MXD
CAMBRIDGE, MA

INFILL DEVELOPMENT CONCEPT PLAN

AMENDMENT 2
RESPONSE TO COMMENTS

NOV 5 2021
SASAKI

R.3.2.1 FIG. 1

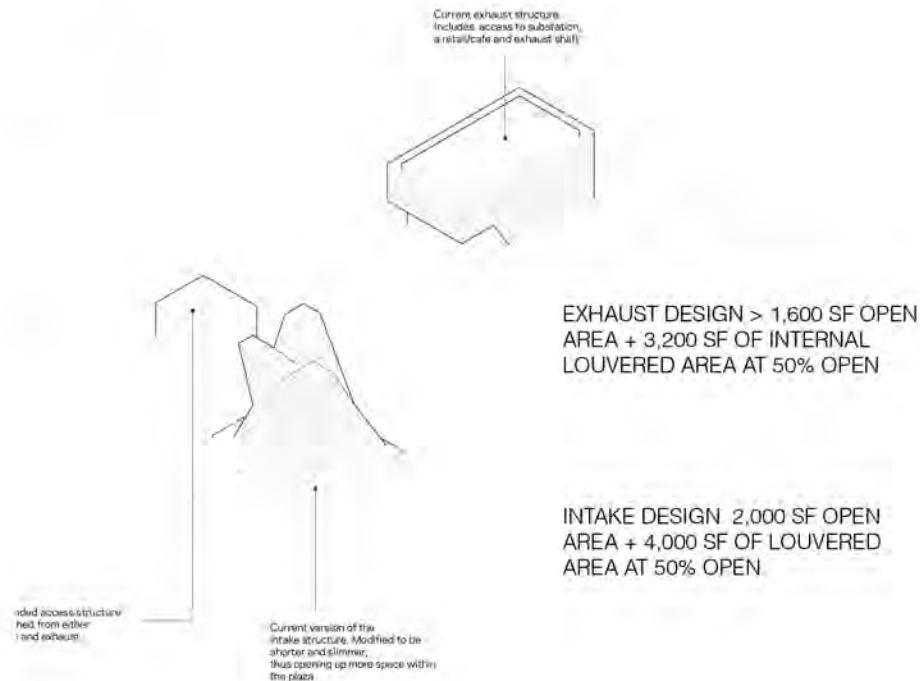
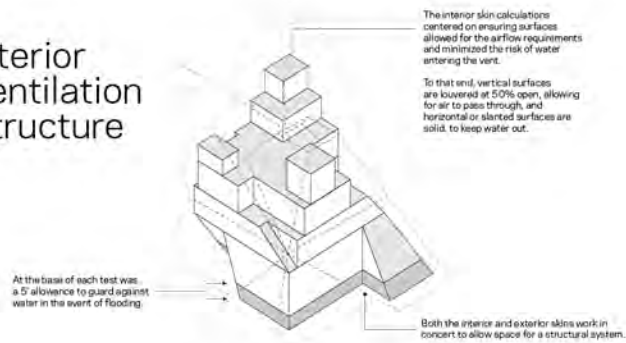
The Applicant received comments requesting additional information on the required ventilation stacks within Center Plaza for the Eversource substation.

First and foremost, it is vital to note that the need for and dimensions of the proposed exhaust and intake structures are rooted in internal substation engineering considerations. The amount of heat that the substation needs to reject, associated calculations of cubic feet of air per minute (CFM) that must pass through the intake and exhaust ducts, and maximum airflow speeds dictate the amount of free area the exhaust and intake structures must have in order to adequately cool the substation facility. These parameters are subsequently influenced by the selection of louvers designed to prevent the intrusion of rain or debris into the substation's ventilation system, which increases the total surface area that must be dedicated to both exhaust and intake structures. For example, louvers with 50% free area require a surface area dedicated to air exhaust or intake 100% greater than the free area initially calculated. Taken together, these variables determine the size of the exhaust and intake structures. The ventilation structures are essential to the functioning of the substation and cannot be eliminated from the proposal.

Required Substation airflow ¹	1.4MM cfm
Exhaust Air Velocity	900 fpm
Exhaust Open Area needed	1,555 SF
Exhaust Internal Louvered Area @ 50% open ²	3,110 SF ³

R.3.2.2 FIG. 1

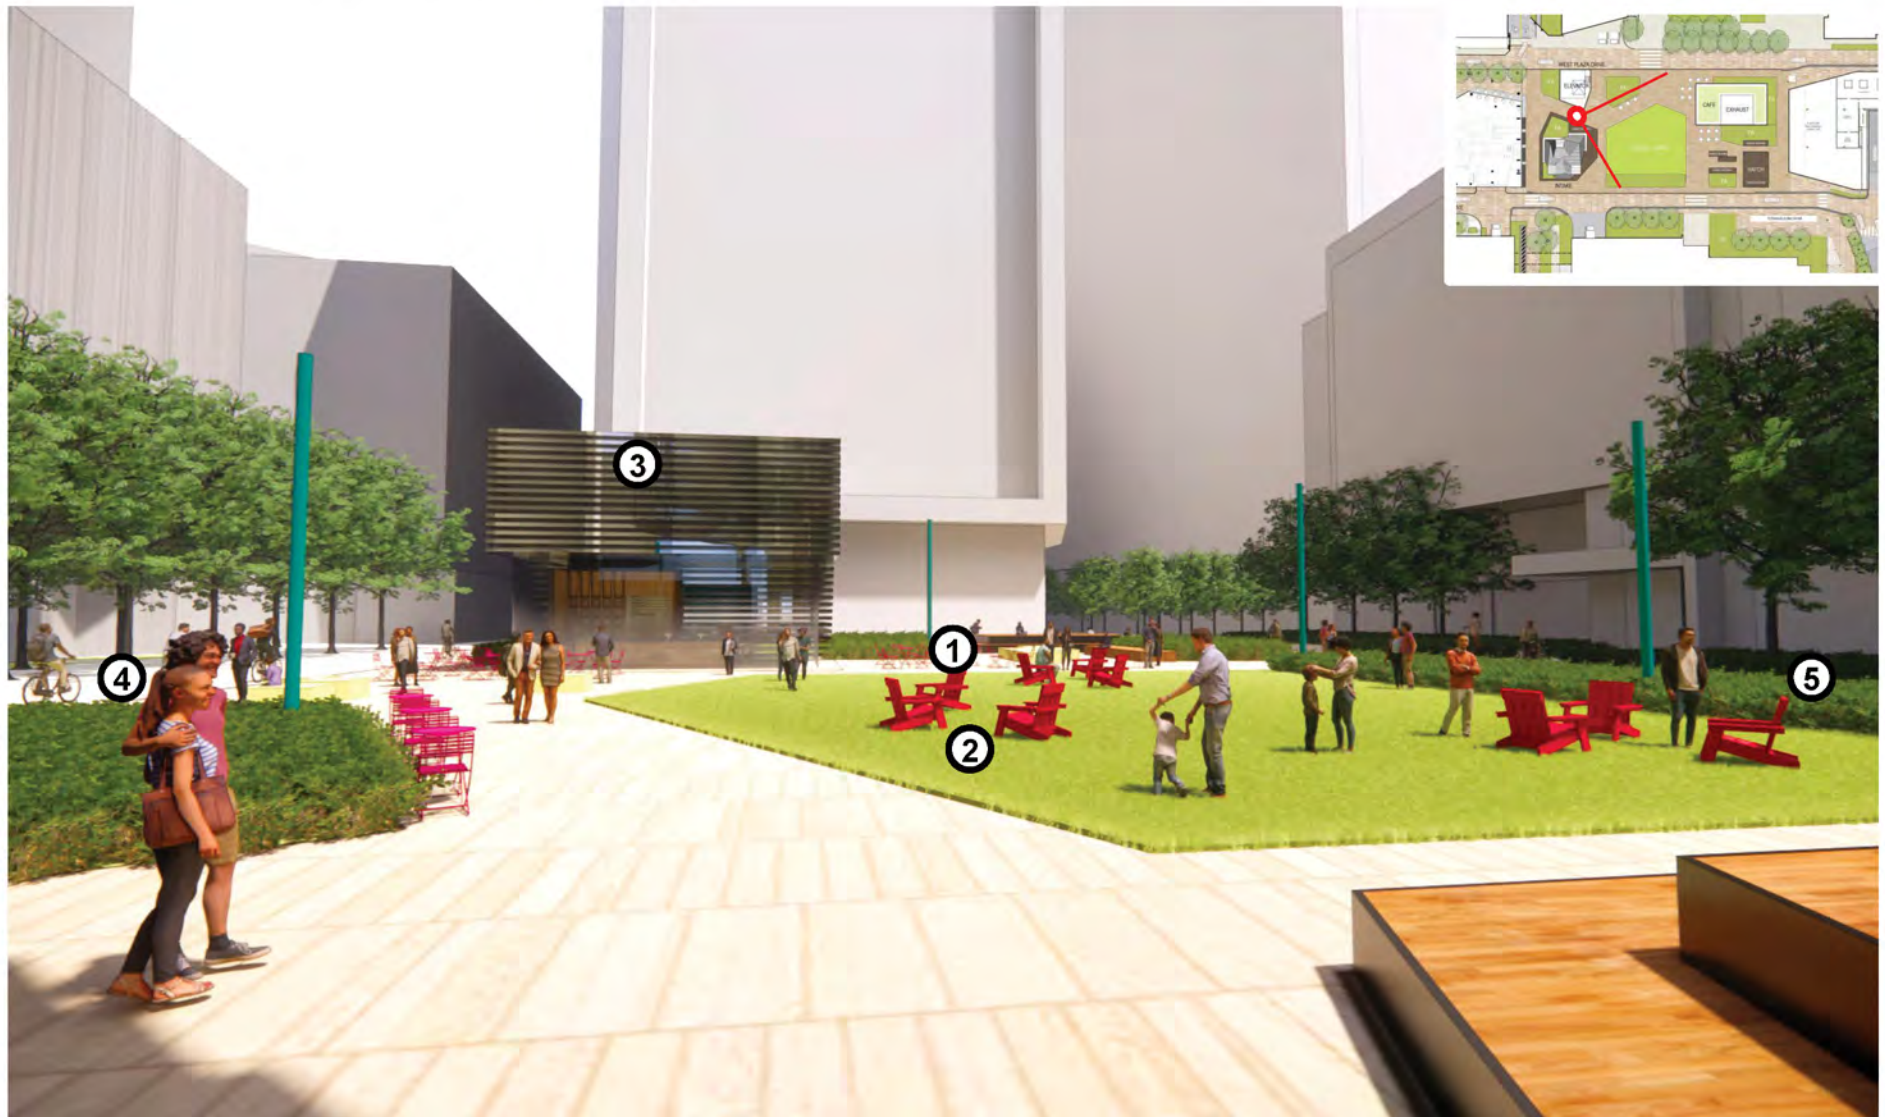
The Applicant received comments on the proposed planting and landscaping scheme for the Center Plaza. In response to this feedback, the Applicant proposes substantial design changes that endeavor specifically to rethink the extent of green space conceived for the Center Plaza itself. Rather than employing flexible hardscape at the center of the Center Plaza as presented at the September 28th joint hearing, the Applicant now proposes a lawn for that area deployed within a unitized system designed to protect the waterproofing of the substation roof. The new lawn coupled with prior strategies that utilize planters and raised beds to support vegetation, collectively boost “green coverage” of the Center Plaza space from (2,000) SF to (7,000) SF, or (23) % overall. Nonetheless, on account of the need to protect the waterproofing of the substation roof trees continue to be excluded from the Center Plaza (though they are certainly contemplated for perimeter terra firma). Additionally, a water feature is planned adjacent to the proposed Residential Building South along Broadway, and a children’s play facility is designated to be constructed within the southern East-West connector.

R.5.1 FIG. 1

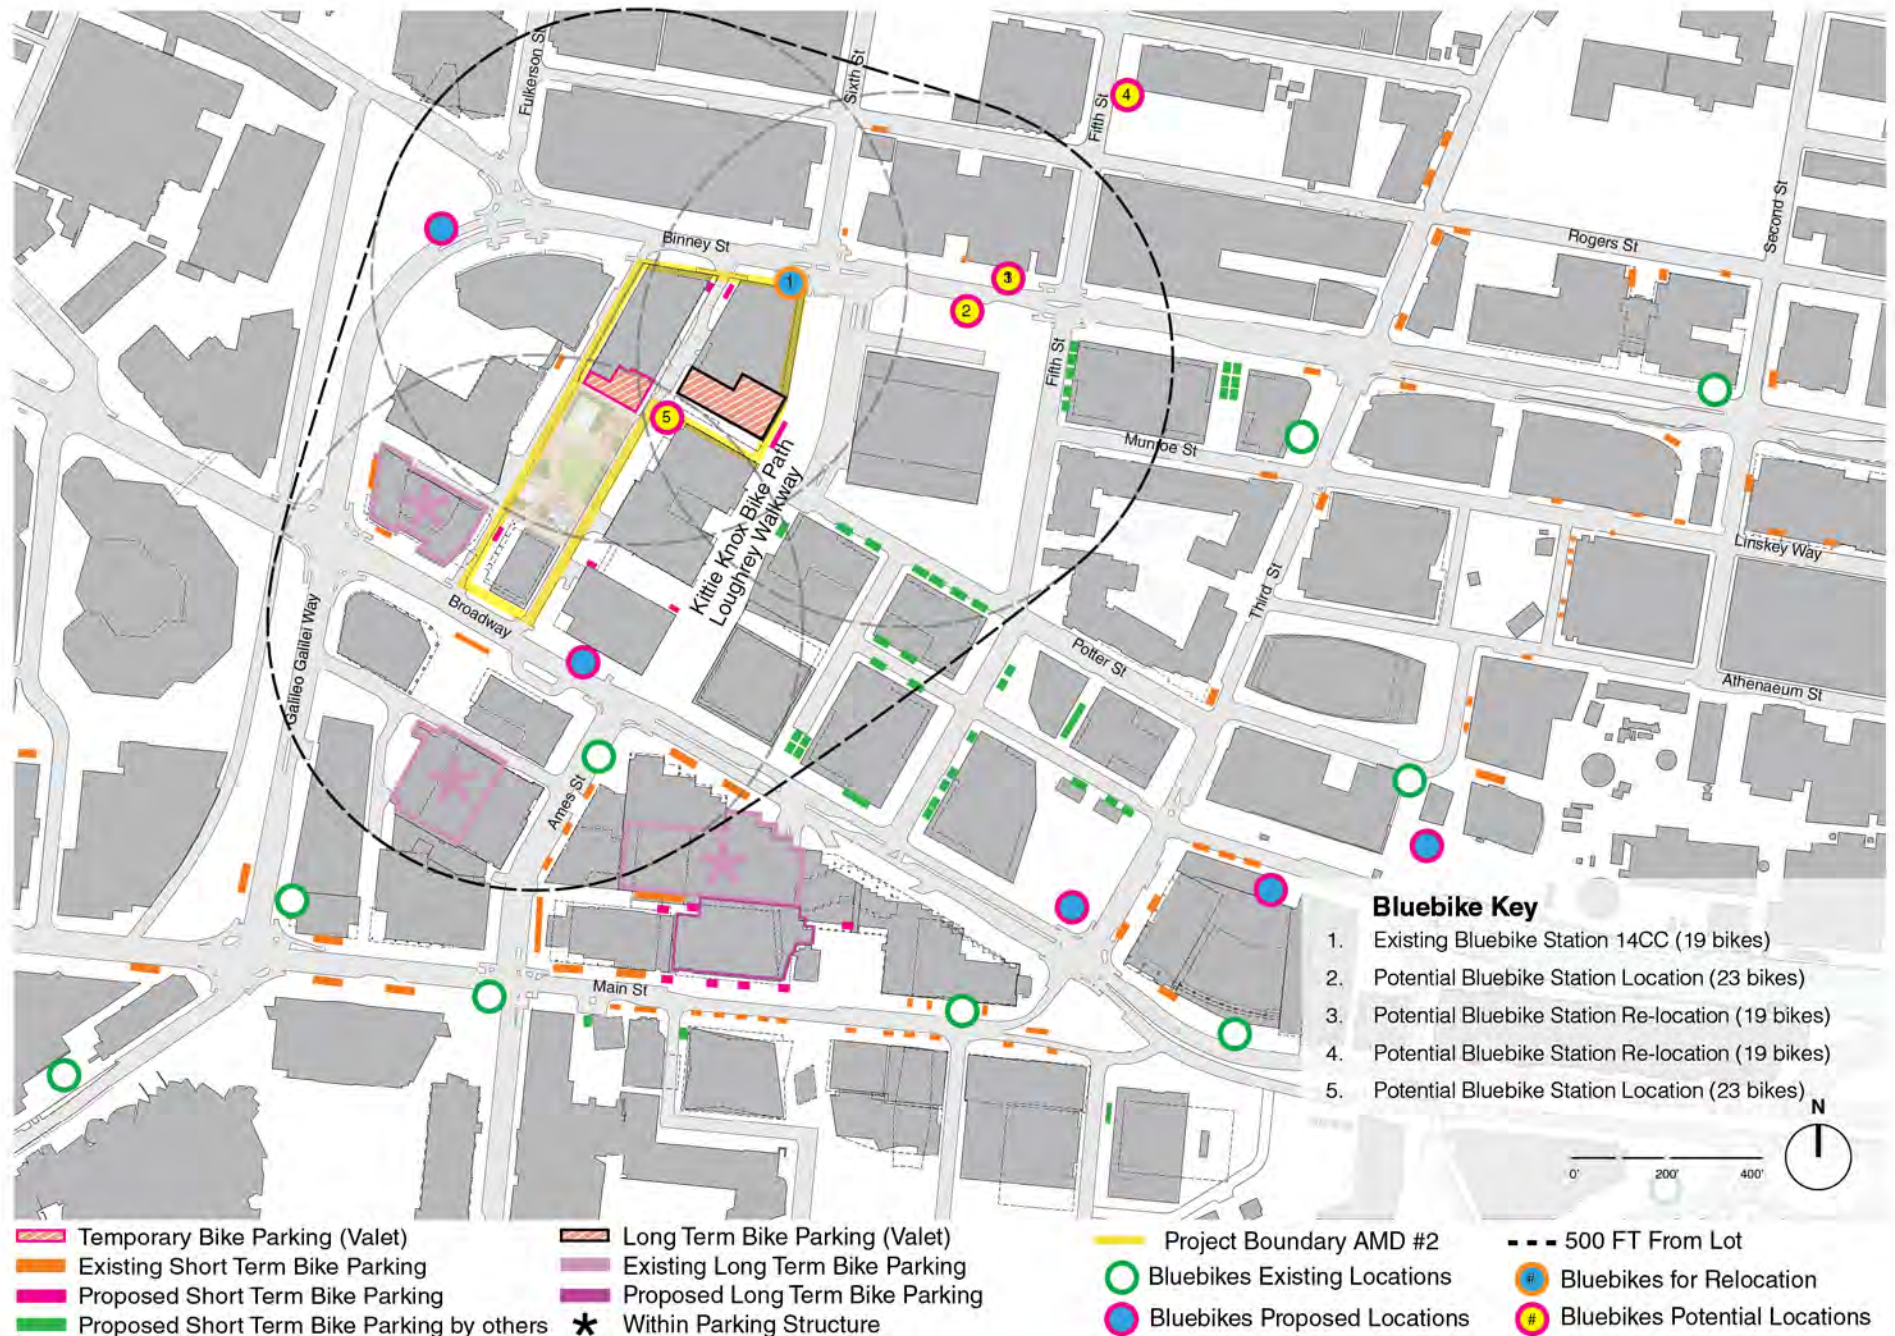
The Applicant received comments requesting additional information on the proposed bicycle valet service.

The Applicant is proposing to address bicycle parking needs via a deliberate blend of strategies permitted under the MXD Zoning Amendment adopted on February 23, 2021. The centerpiece of the Applicant's long-term bicycle parking strategy consists of a new bicycle valet facility, but also includes the provision of both long and short-term traditional self-park racks, as well as one new 23 dock BlueBikes bike share rack (the existing 19 dock Station at 250 Binney Street will be relocated). Refer to R.5.1 FIG.1 - FIG.2 for exhibits providing an overview of campus bicycle parking.

R.6.1 FIG. 1

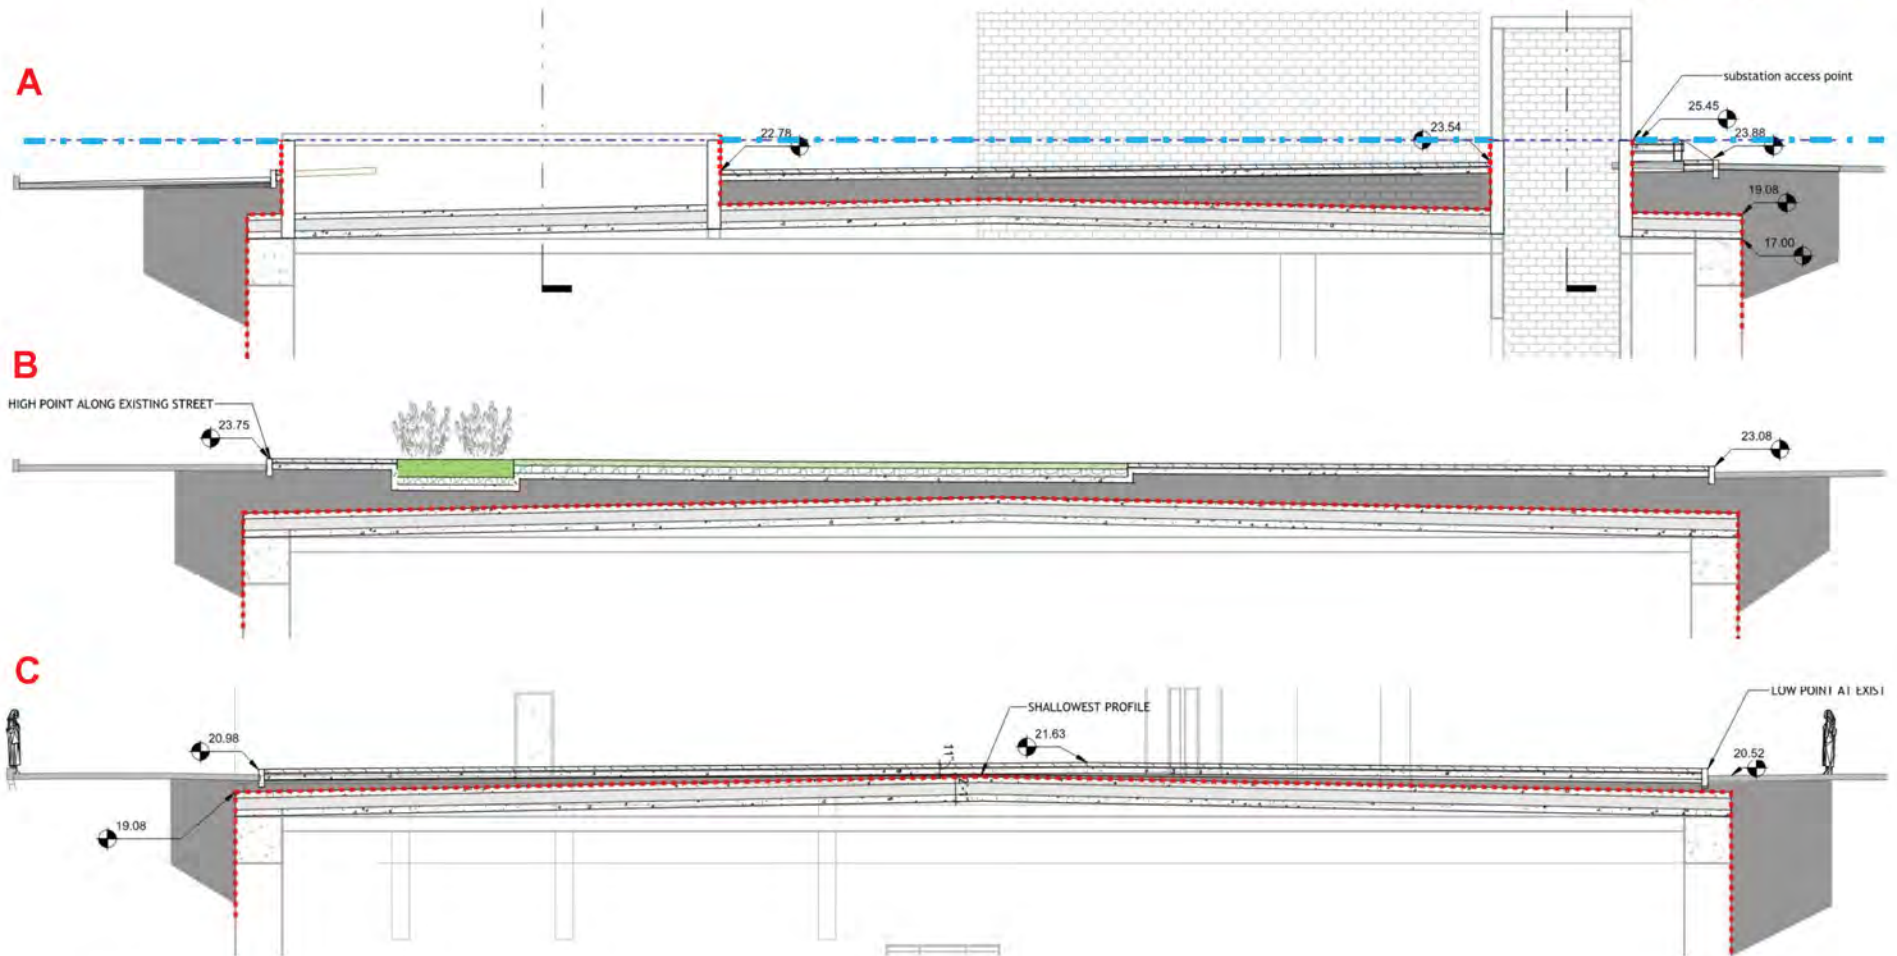
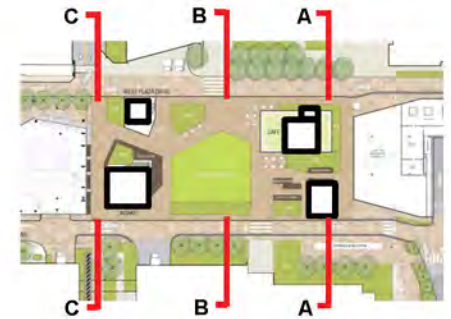
The Applicant received comments requesting additional information on proposed resilience measures for the substation, and how those measures may influence the design of the Center Plaza.

Beginning with the substation and Center Plaza, the Applicant in this instance is proposing to rely upon several distinct lines of defense congruent with existing infrastructure and key features of the public realm. The Applicant proposes that all vertical penetrations in the Center Plaza/substation roof should be raised to an elevation of 25.45 feet so as to prevent water infiltration into the substation in the event of a 2070 100-year flood. Vertical elements impacted by this strategy include the exhaust and intake structures that provide ventilation for the substation facility, among others. The substation itself will also utilize a pitched “shed” roof structure to direct water around the substation vault slurry wall, reducing the likelihood of water infiltration from precipitation. Wrapped on top of this roof structure will be a layer of high-performance waterproofing to further buttress the substation vault’s ability to resist water infiltration. These measures, coupled with the substation vault’s structure and slurry wall design—are anticipated to ensure the long-term viability of the electrical substation.
